ST. TAMMANY PARISH

Addendum No.: 2

Bid#: 24-35-2

Project Name: Diversified Water Well Pretreatment System

NEW ELECTRICAL RISER DIAGRAM

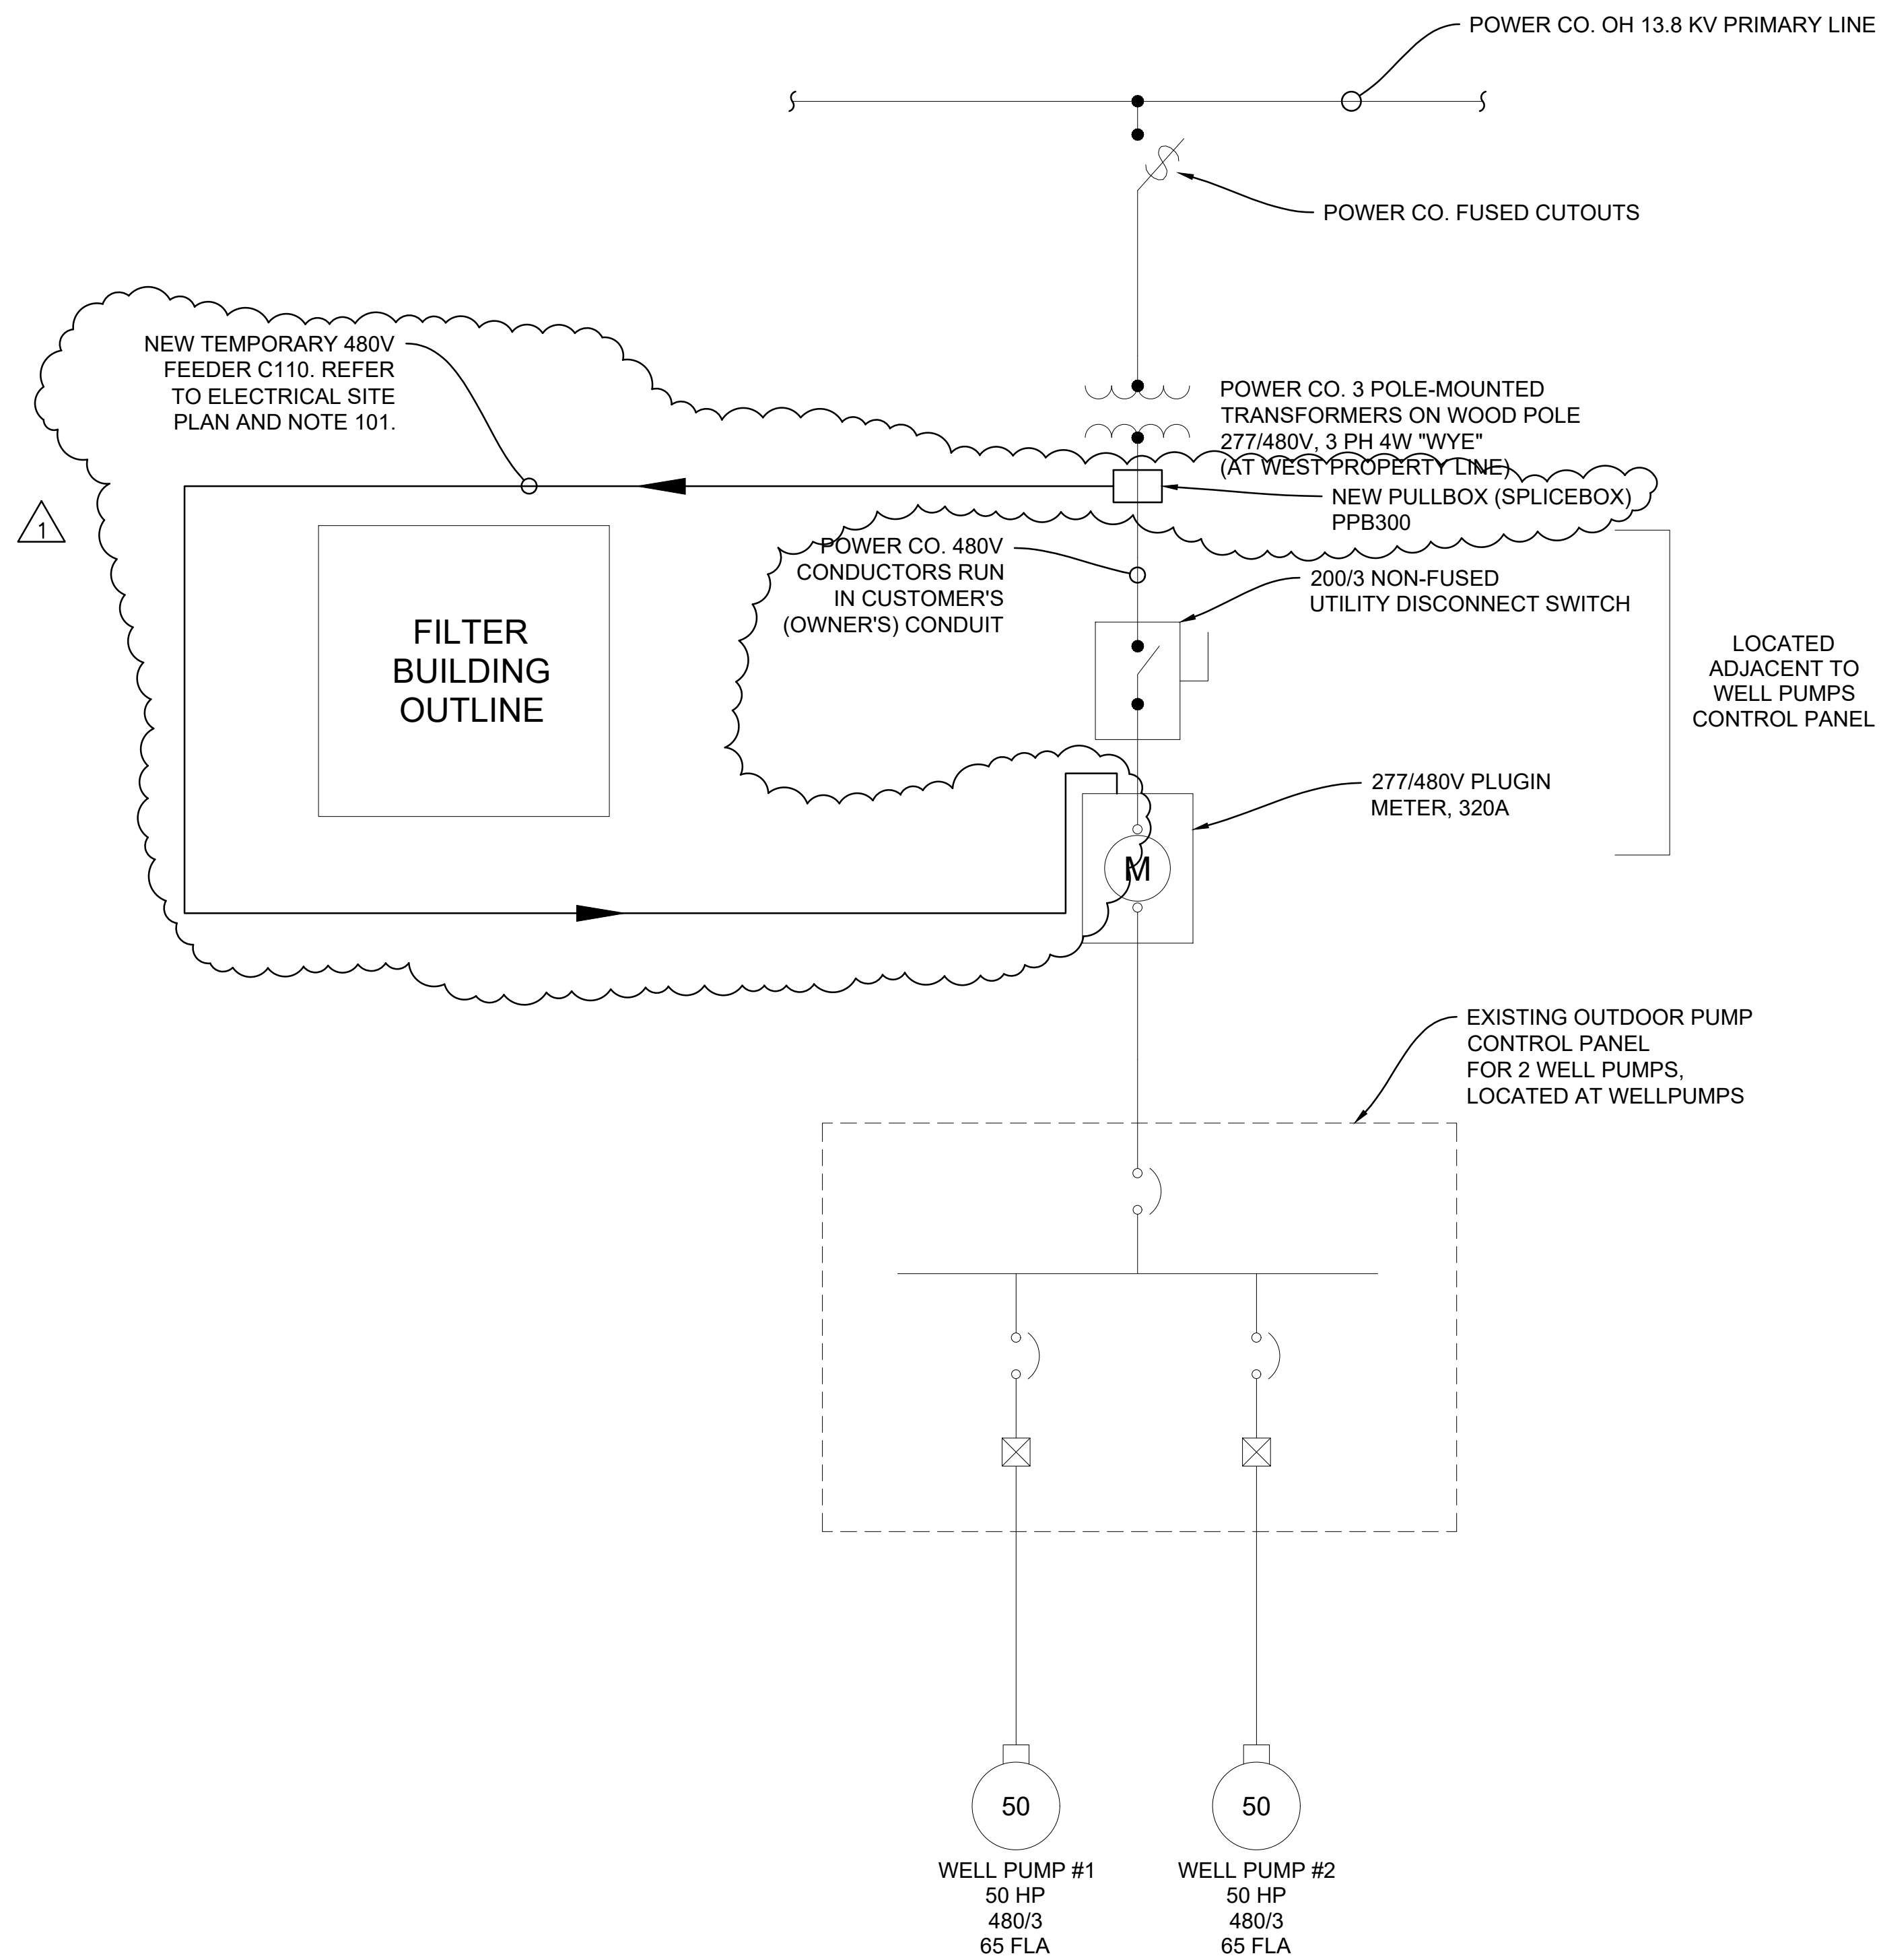
Question 2: Drawing E-004 bottom of page has 4 notes C401, C402, C501 and C601 for conduit and wire sizing however there are not referenced on E-016 Conduit and Wire Chart, please advise to sizing.

Question 4: Drawing E-004 New One Line Riser from DP-1 circuit noted C111 is incorrect and should be C113, from Pump Control Panel to P2 circuit noted C113 should be C111. Please confirm.

Question 5: Drawing E-004 bottom left notes above Pad Mounted Transformer calls for two 6" steel thimbles (sleeves through loft deck for 2-3-1/2" conduits for normal power and two 6" steel thimbles for 2-3-1/2 conduits for standby generator power, however the conduit sizing C103 and C105 respectively call for 4" conduits, is note in error?

Question 6: Drawing E-004 indicates thimbles through loft floor for 4 additional conduits, not sized, coming from generator and going to ATS, need conduit and thimble sizing?

Answer 2: Revised Conduit and Wire sizes are indicated on revised electrical sheet E-016, issued with this Addendum.

Answer 4: Revised Conduit and Wire sizes are indicated on revised electrical sheet E-016, issued with this Addendum.

Answer 5: Revised Conduit and Wire sizes are indicated on revised electrical sheet E-016, issued with this Addendum. Please note that a 3-1/2" conduit has a coupling which has a 5"(+/-) OD, which can pass through a 6" ID steel sleeve, if need be.

Answer 6: Revised Conduit and Wire sizes are indicated on revised electrical sheet E-016, issued with this Addendum. Please note that conduits have a coupling which has a larger OD than the stated conduit size, and the larger steel sleeves allow the couplings to pass through, if need be.

SHEET NO.
E-005
SHEET 79 OF 92

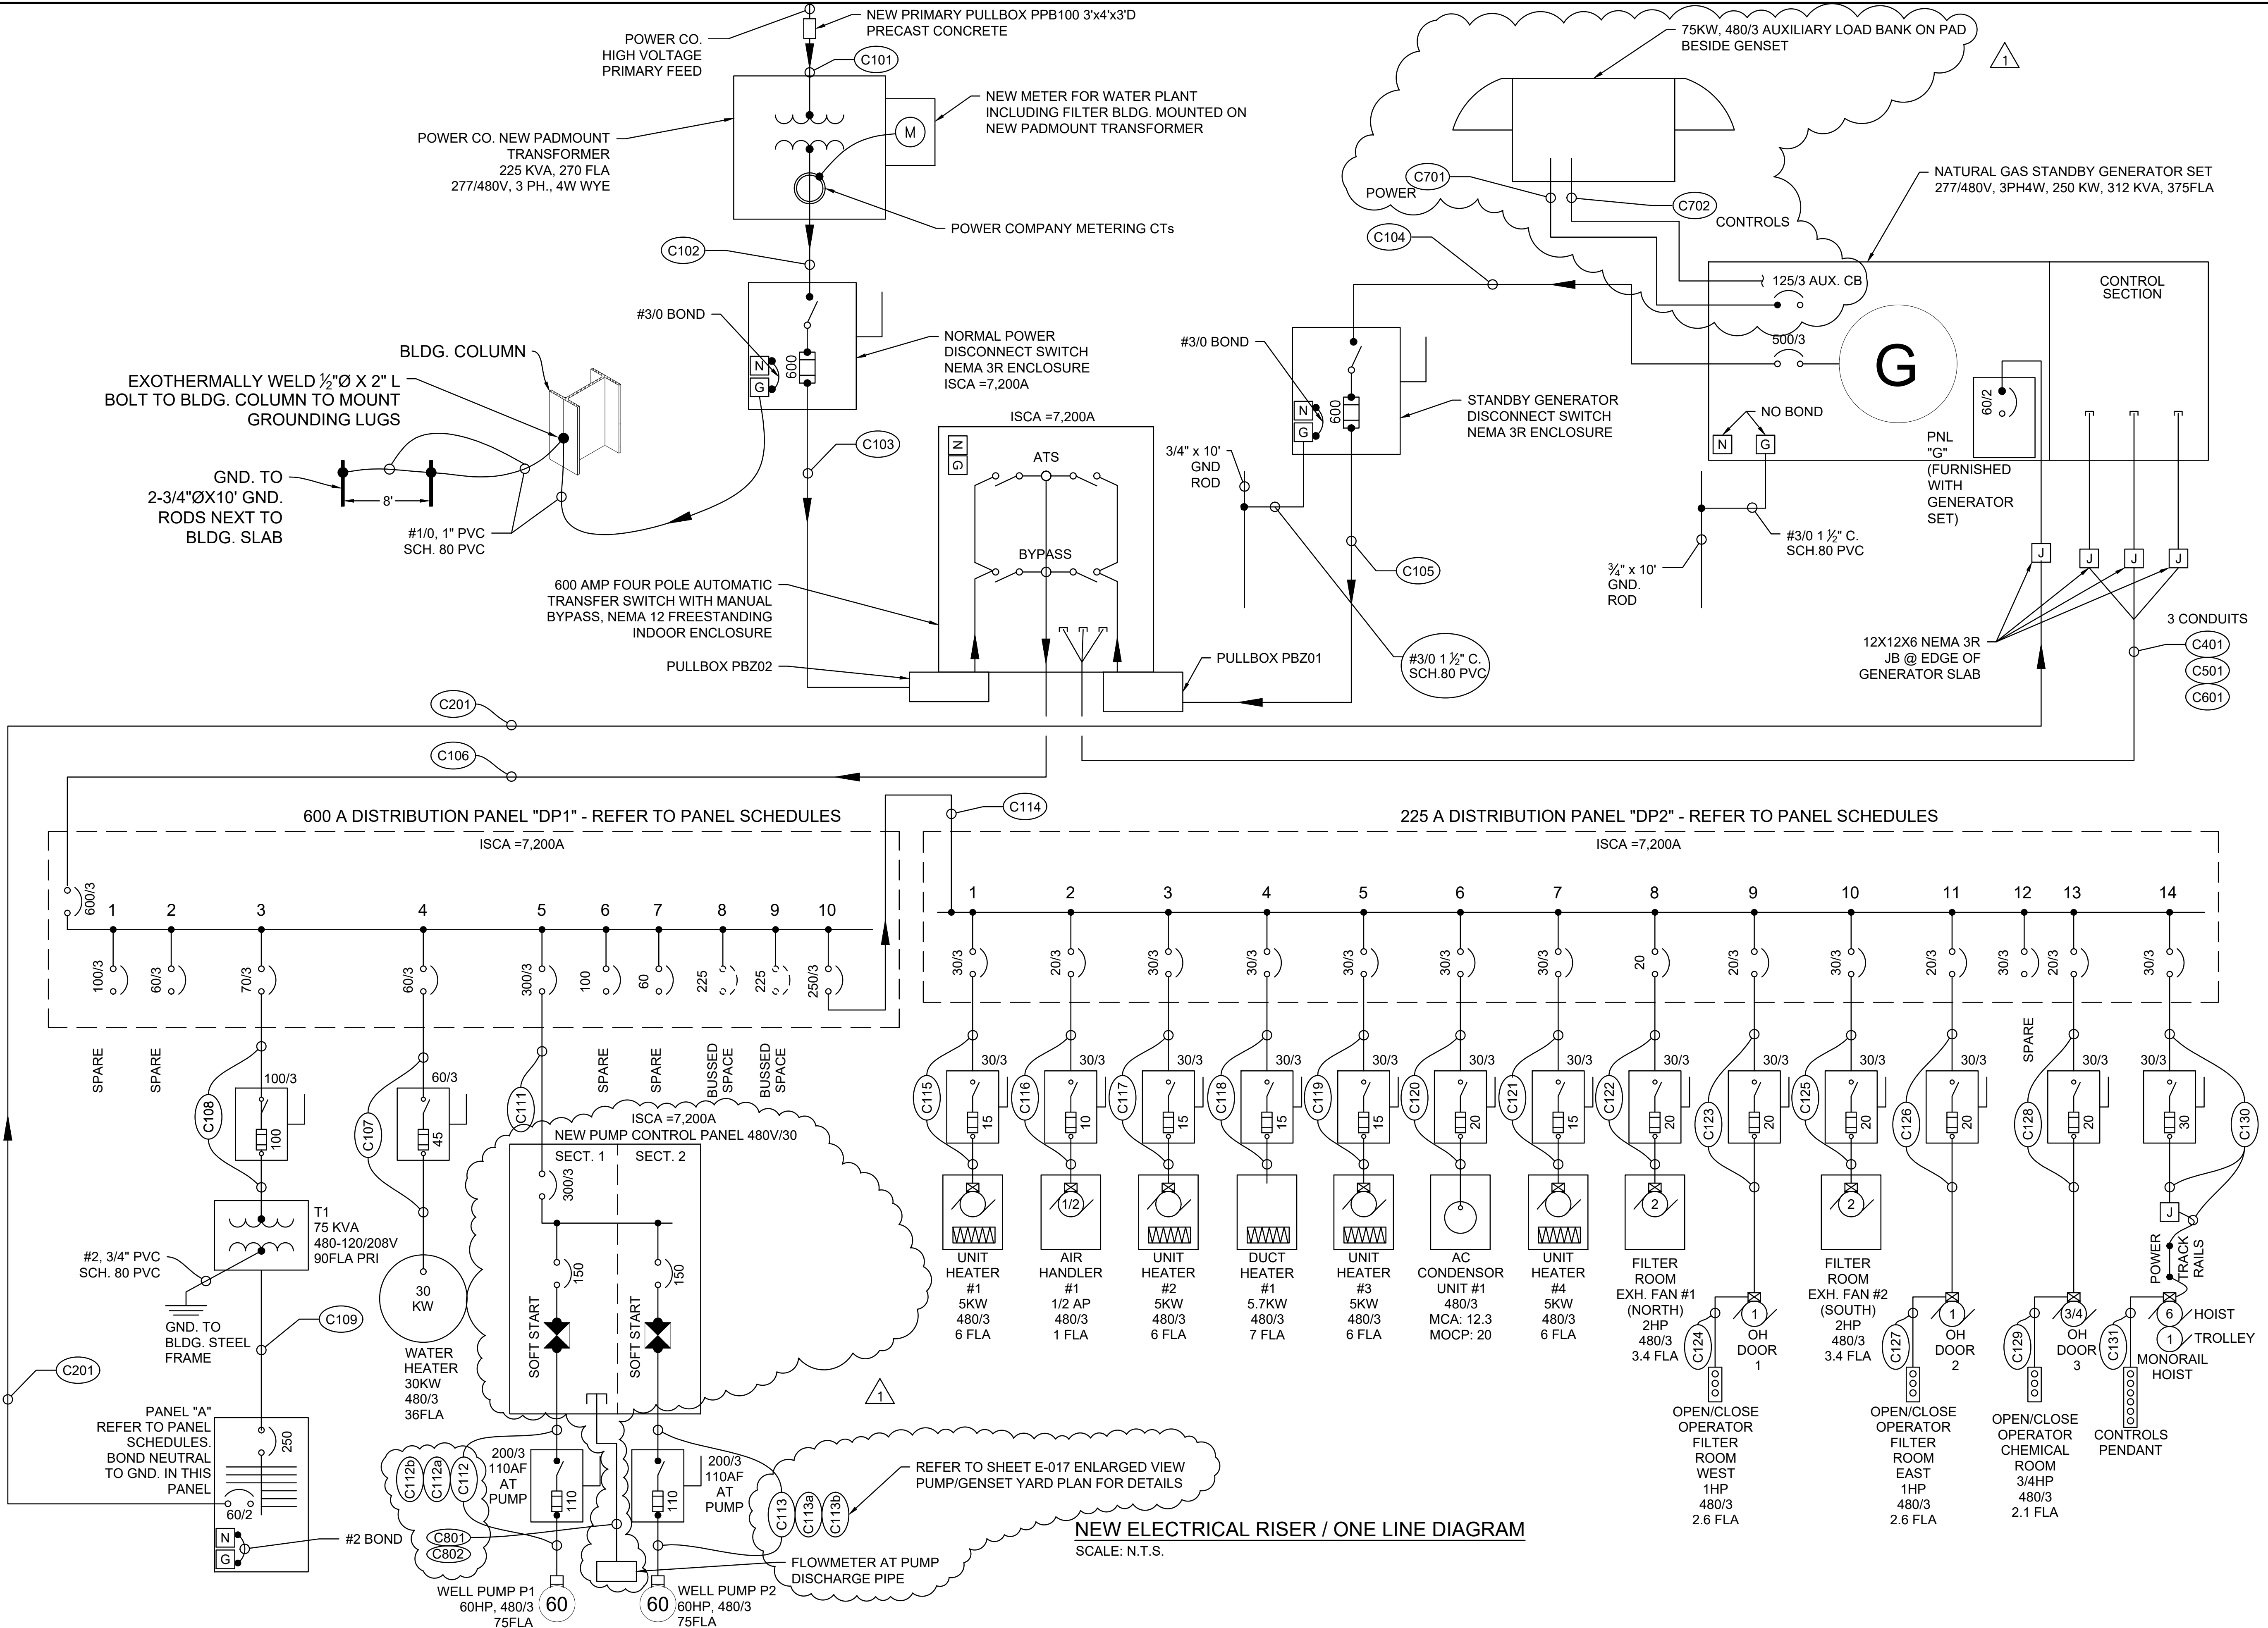
Question 7: Drawings E-003 and E-005 show existing Electrical One Line Drawing which appear to be the same just different views; is this service to remain active since there are no demolition of electrical equipment shown on any drawings?

Answer 7: Refer to the attached revised electrical drawings which show temporary electrical feeder to operate well pumps during construction of filter building.
